# SPACE HOUSE

## Planning Condition 18PP Discharge Report

**RE: Spacehouse – Planning Condition 18PP – Landscape Details**

## VEHICULAR RAMP AMENDMENT

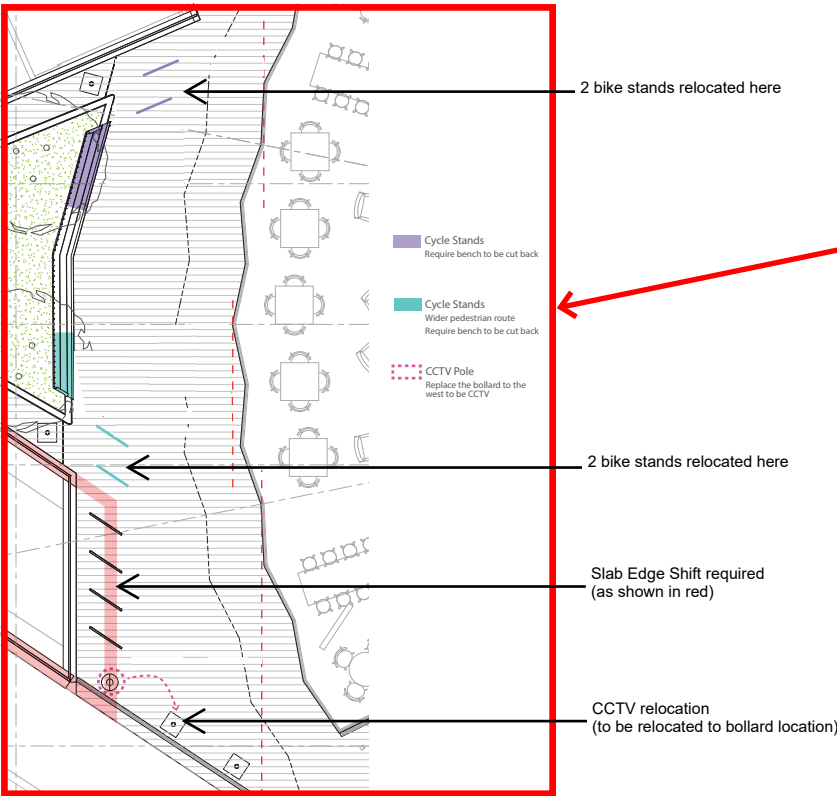
Site conditions have revealed that the slab edge along the ramp provided a head height of 1.9m. To rectify this, the line of the slab needs to shift to the east to allow for sufficient head height down the ramp (2.1m). This will result in 4 bike stands and a single CCTV pole to be relocated.

- The ramp slab edge shift eastward approximately 1m to allow for sufficient head height down the ramp.
- The previous 4 bike stands above the ramp will be relocated to either side of the planter with 2 no. bike stands on either side of the planter.
- The single CCTV pole will be relocated and will replace a previously shown bollard

The change has been reviewed by the planning officer who advised it was acceptable in principle and could be submitted under condition 18.
